SUBJECT: Triangle Expressway Southeast Extension (Complete 540) from NC 55 Bypass in Apex to US 64/264 (I-87) in Knightdale, Wake and Johnston Counties; Federal Aid No. STP-0540(19), STP-0540(20), and STP-0540(21); WBS Nos. 37673.1.TA1, 35516.1.TA1, and 35517.1.TA1; STIP Project Nos. R-2721, R-2828, and R-2829

Also, please reference your November 25, 2025 email, requesting modification of the permit to authorize change of impacts at Permit Sites 14, 15, and 31, for R-2829B. The modifications at 14 and 15 are necessary for an alternate Neuse River bridge design that reduces the overall length of the bridge by 290 feet, saves approximately \$2 million in construction costs, reduces bridge construction time by 23 weeks (including short term impacts to the river and the Neuse River Greenway), and reduces required concrete truck trips by 262 loads.

The Corps has completed the evaluation of your request and has determined that it is appropriate and reasonable, and that no public notice is required for this modification. Therefore, the permit is modified as requested and as shown on the enclosed R-2829B Mod Permit Drawings, Sheets 1, 30-39, 76, and 110-112, submitted November 25, 2025.

SITE 15

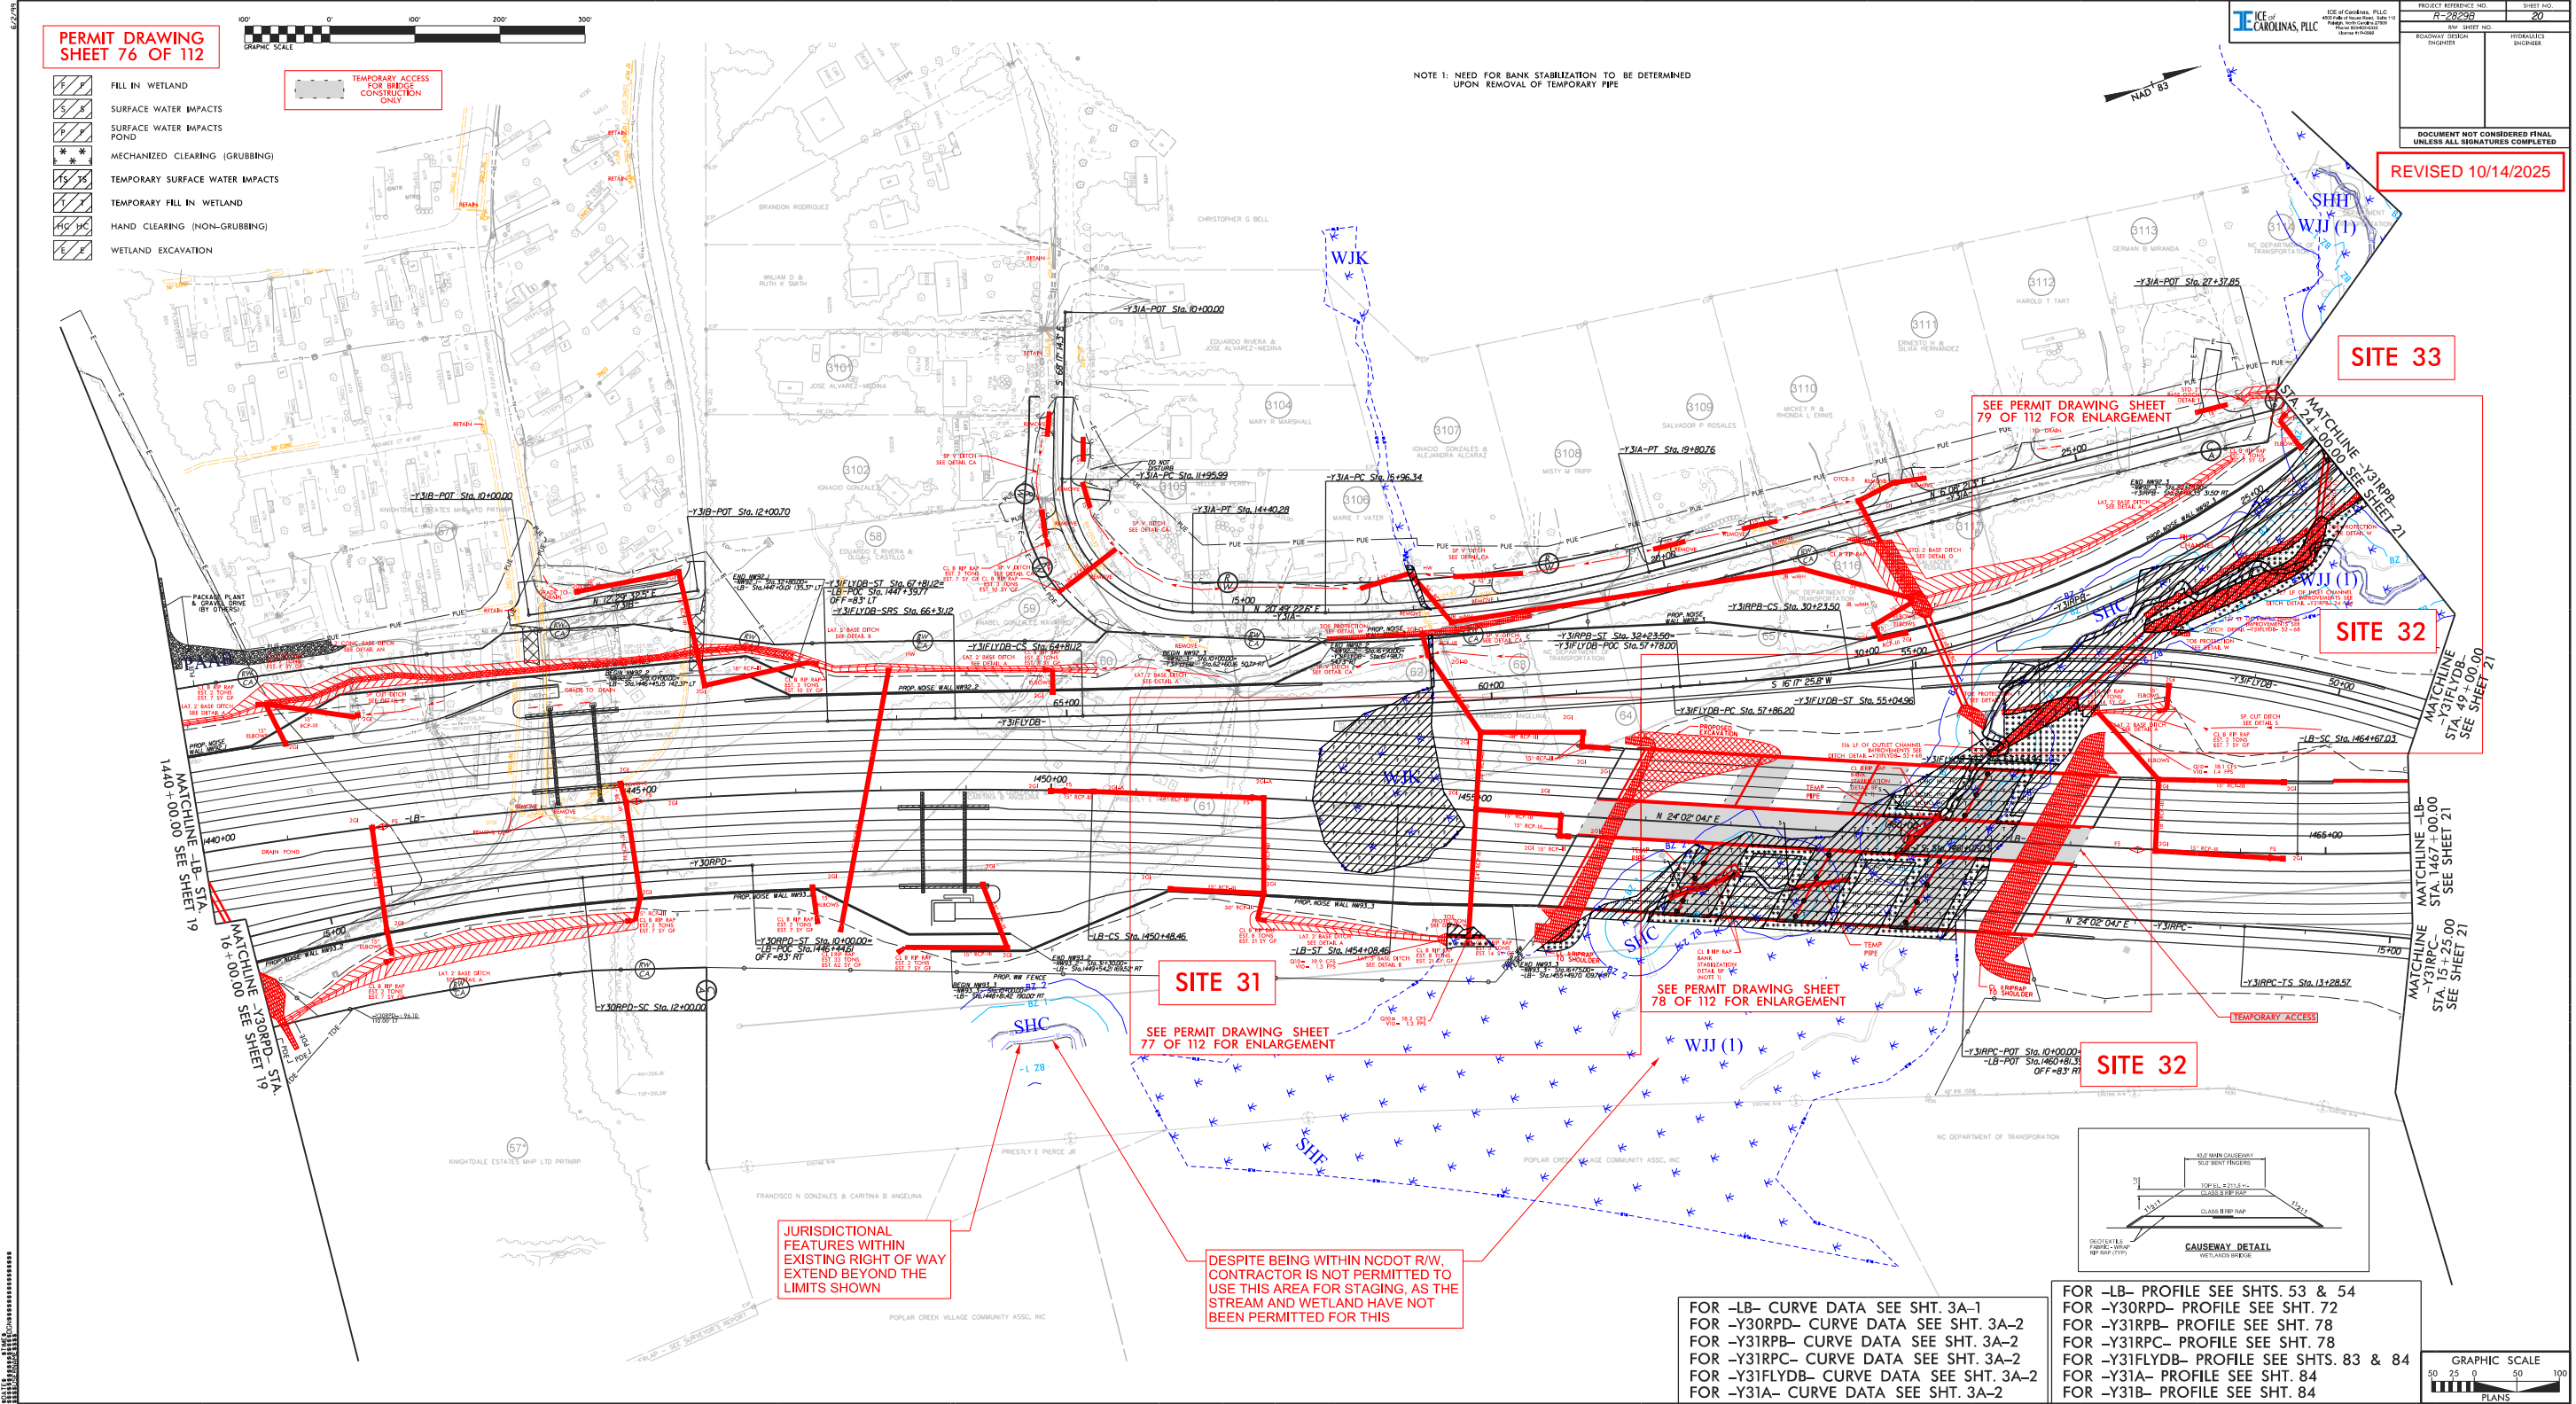
Site 15: Neuse River – Bank stabilization

- Permanent Stream Impact: 51 lf (previously 76 lf - decrease of 25 lf)
- Temporary Stream Impact: 73 lf (previously 108 lf - decrease of 35 lf)
